PROVIDENCE PARK WEST PRO

PRO CONCEPT PLAN

PRO PLANS FOR:
PROVIDENCE MEADOWS

SHEET TITLE:
OVERALL SITE PLAN

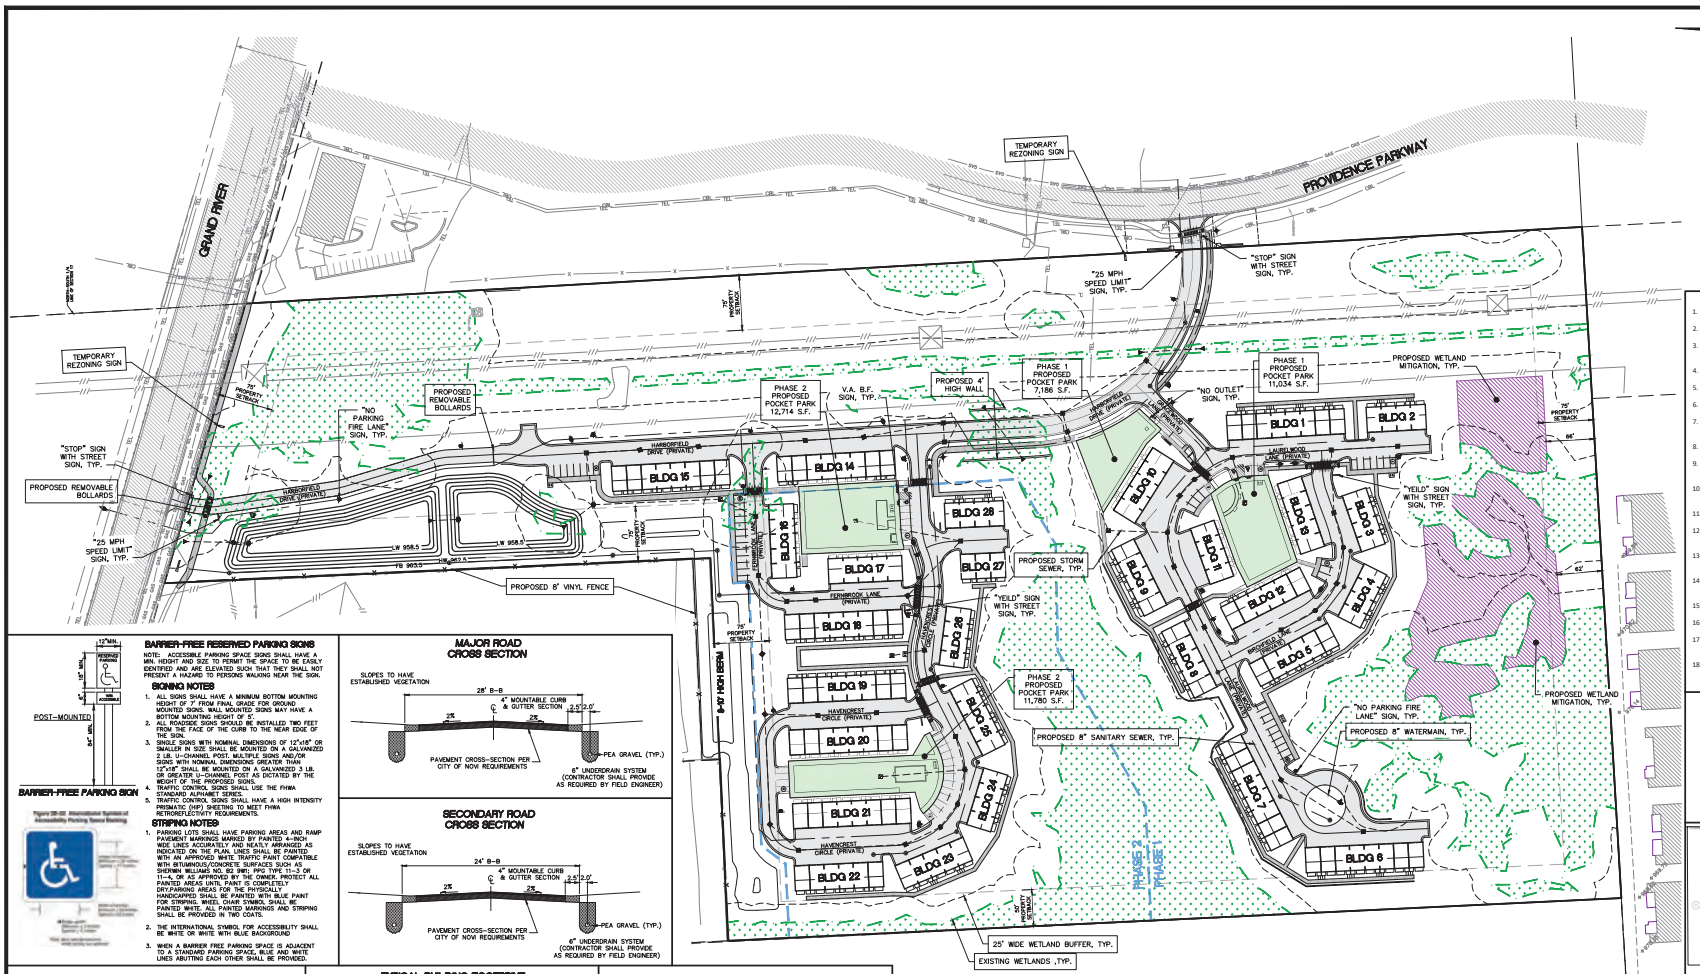
h. **Rezoning Sign Location Plan:** Wording and size of the required rezoning signage is indicated on sheet S-1 and meets the requirements. The location indicated on Grand River Avenue is approved. An additional sign is now shown along the Providence Parkway frontage, near where the proposed entrance to the community is proposed.

3. Usable Open Space: Sheet C7 indicates areas of Usable Open Space Plan. The plan shows phase 1 would have 22,620 square feet and phase 2 would have 28,144 square feet. **These areas exceed the requirement by 29% and 93% respectively, which represents an enhancement of the project area beyond what could otherwise be required.**

4. **Distance between Buildings** *(Sec 3.8.2.H): A Zoning Ordinance deviation is requested to reduce the building separation distance from the calculated formula as shown on sheet C7 to a minimum of 15 feet.* **This deviation enables the layout of this project to fit within the available space while minimizing wetland and woodland impacts.**

EXTERNAL SITE ACCESS AND OPERATIONS				
No.	**Item**	**Proposed**	**Compliance**	**Remarks**
7	External coordination (Road agency)	Not indicated	**Inconclusive**	Coordination with RCOC will be required for work along Grand River Avenue.
8	External Sidewalk | Master Plan & EDM	8' proposed	Met	
9	Sidewalk Ramps | EDM 7.4 & R-28-K	Indicated and detail provided	Met	
10	Any Other Comments:	The rezoning sign detail on sheet C7 states zoning change proposed to "RM-1" instead of "RM-2".

typical RM-2 dev. We have revised our Requested Deviations to include all listed in the review letter. See Sheet C7

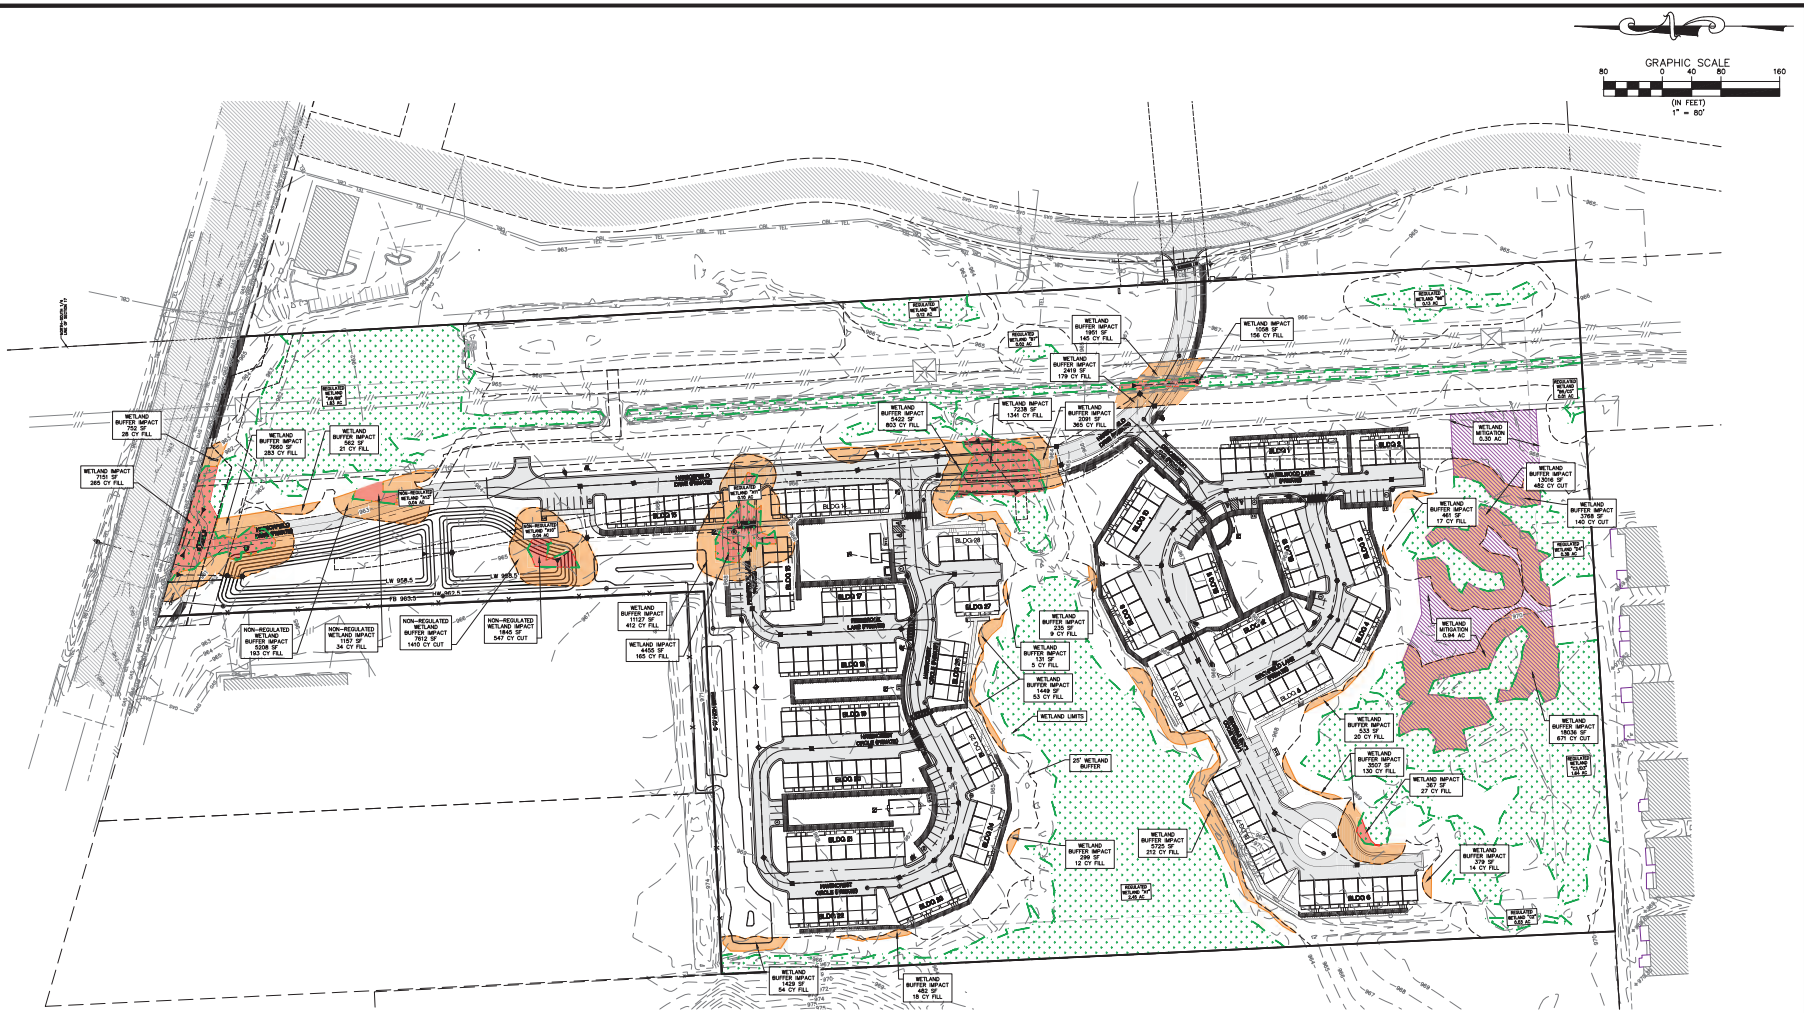
Requested Edit/Clarification: On Sheet C19, the symbology for wetland buffer impact and wetland mitigation in the wetland disturbance legend is reversed and should be fixed to reflect the symbology in the plan. Additionally, it is assumed that all wetland impacts are permanent. However, if any wetland impacts are temporary, please note as such in the site plan (i.e., on sheet C19 in the column headers of wetland impacts).
